Crop Improvement and Agriculture Precinct Reconstruction Brief

University of Ghana bicycle exploration game | Instructions for Claude

Picture 1 The large blue circle selects the wrong game block; violet arrows select comparison buildings.

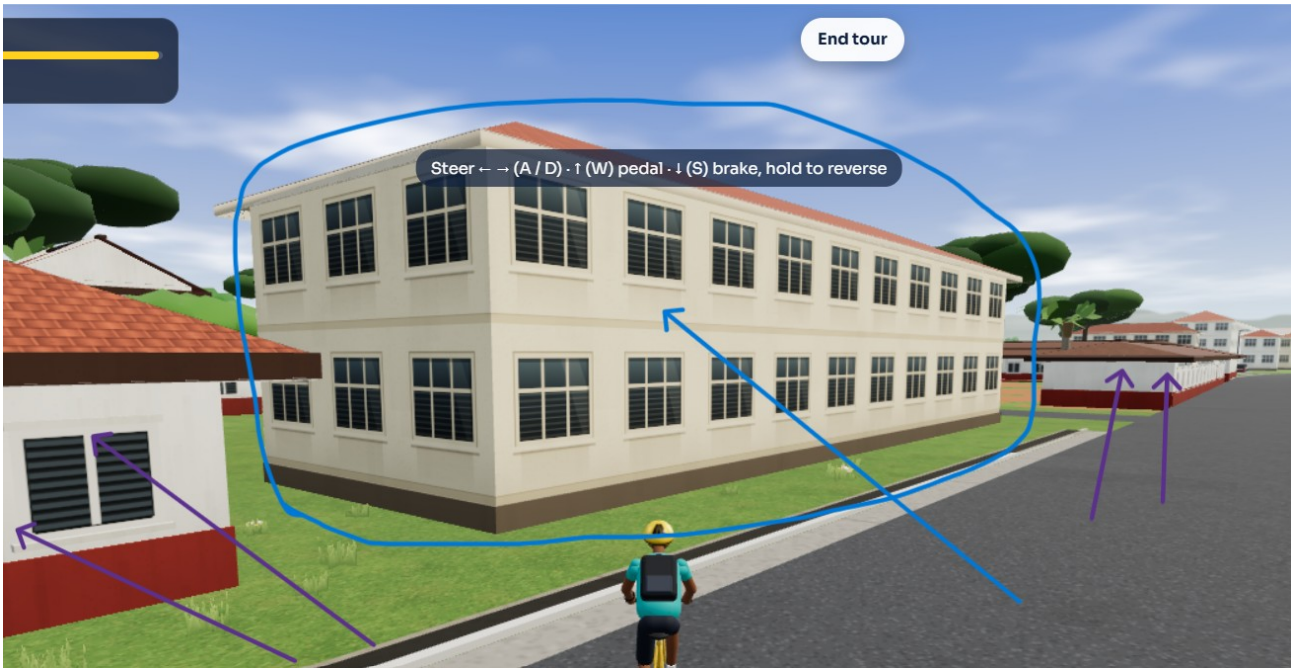
The selected corner building is a bulky two-storey cream classroom block with repeated large glazed bays and a brown base. The violet arrows identify lower white buildings with a red lower wall and tiled red roofs. The circled mass is therefore too tall and too institutional in its window pattern, wall treatment and overall silhouette for this location.

- Replace the selected two-storey block with a low volume matching the indicated neighboring building family. Set the eave and ridge against the violet-arrow buildings from this camera; remove the unsupported upper floor instead of shrinking its window texture.
- Use white or light plaster walls, a distinct red lower band, a weathered red tiled pitched roof with deep eaves, and the smaller dark window or louver divisions that are actually supported by the neighboring views. Vary openings by elevation rather than cloning the old classroom bays.
- Keep its roadside footprint and adjacent low buildings coherent. Recheck the corner, grass strip, curb and road after changing its width and roof overhang. Do not globally convert other confirmed two-storey campus blocks.

Picture 4 Game rear view with blue-circled low objects

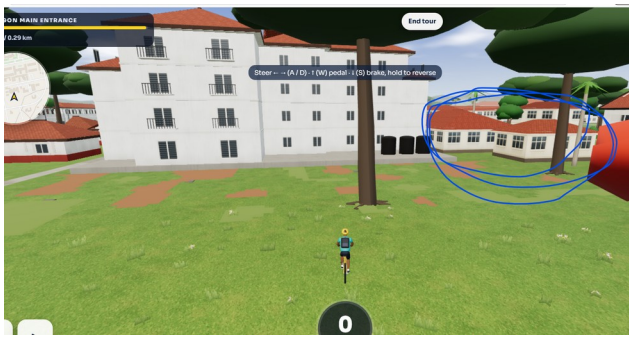
The game fills the right side behind the tall building with repeated generic low blocks and large identical windows. The yellow circle in the real aerial isolates a compact, low white annex with a broad aged red tiled hip roof, limited dark openings, small wall equipment and a more constrained ground edge. The tall Crop Improvement rear wall is an alignment anchor. Black cylindrical water tanks on a pale raised base sit between the foreground yard and annex in the real view.

- Use one coherent low annex at the yellow-circled position. Match its roof footprint and pitch, modest one-storey wall height, sparse windows and connection or separation from the tall building. Remove extraneous repeated blocks only where they conflict with this target.
- Place the black ribbed tanks on their real raised plinth, with simple visible service piping and sensible collision. Avoid a made-up utility maze. Add the small wall-mounted units only where readable.
- Break the broad game lawn into patchy grass, reddish worn earth and connected narrow concrete paths. Keep the yard traversable and the building base grounded; do not flatten the rear site's local grade without checking the reference.

Picture 8 Game map. The blue boundary selects the agriculture group above the Crop Improvement label.

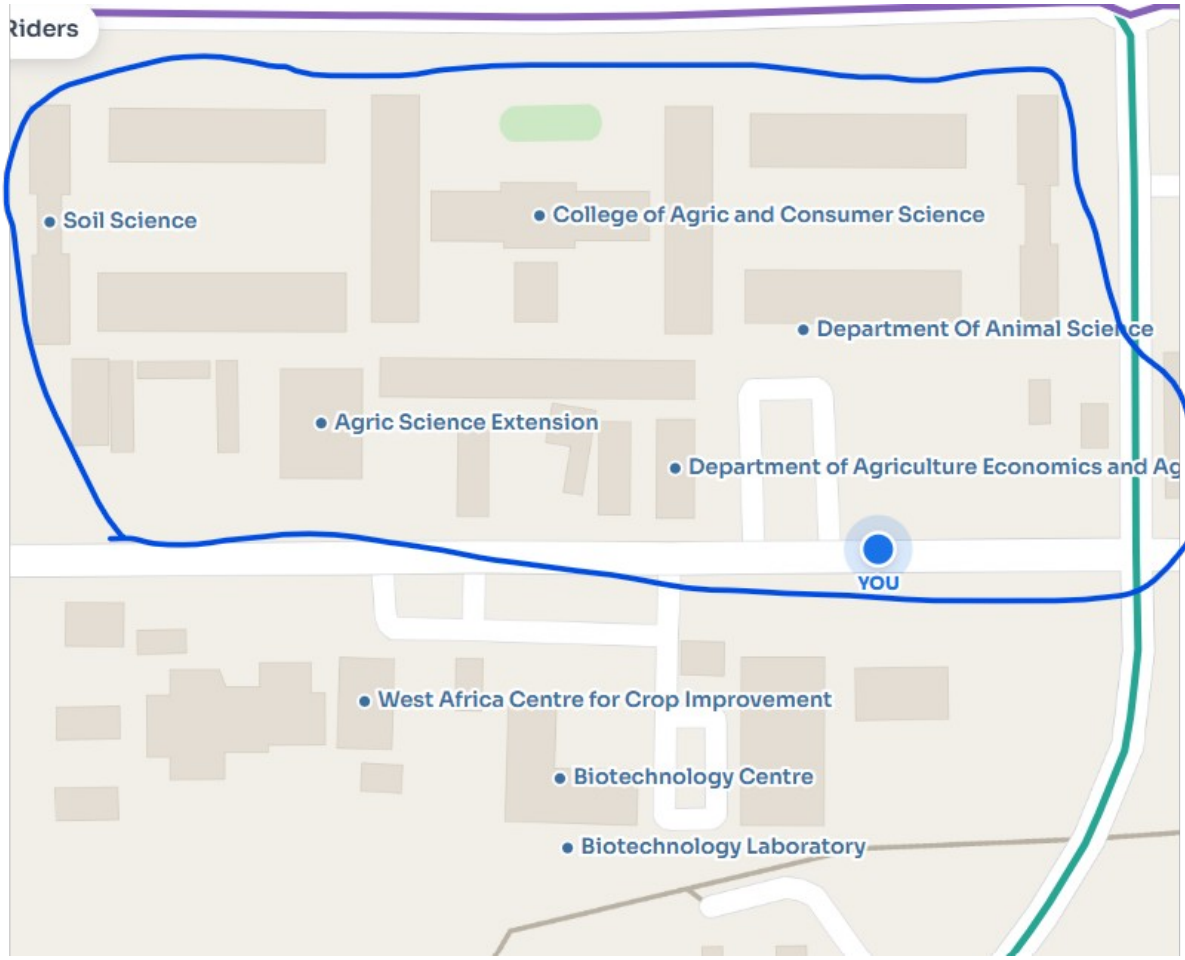
In the displayed map crop, the blue-circled group lies above the West Africa Centre for Crop Improvement, across the intervening route. Labels within it include Soil Science, Agric Science Extension, Department of Animal Science and Department of Agriculture Economics and related units. The College of Agric and Consumer Science label sits in the upper middle and its building was already corrected. These labels help identify scene objects; do not turn map text into freestanding signs.

- Find each selected object and record its scene identifier, approximate footprint, orientation, roof type and storey count before editing. Replace only the wrong masses within the circled group, and retain the corrected College building except for necessary alignment at shared paths.
- Use the route that separates the upper group from Crop Improvement as a stable plan anchor. Preserve passages between departments and the approach from the road, allowing bicycle traversal where the current game supports it.
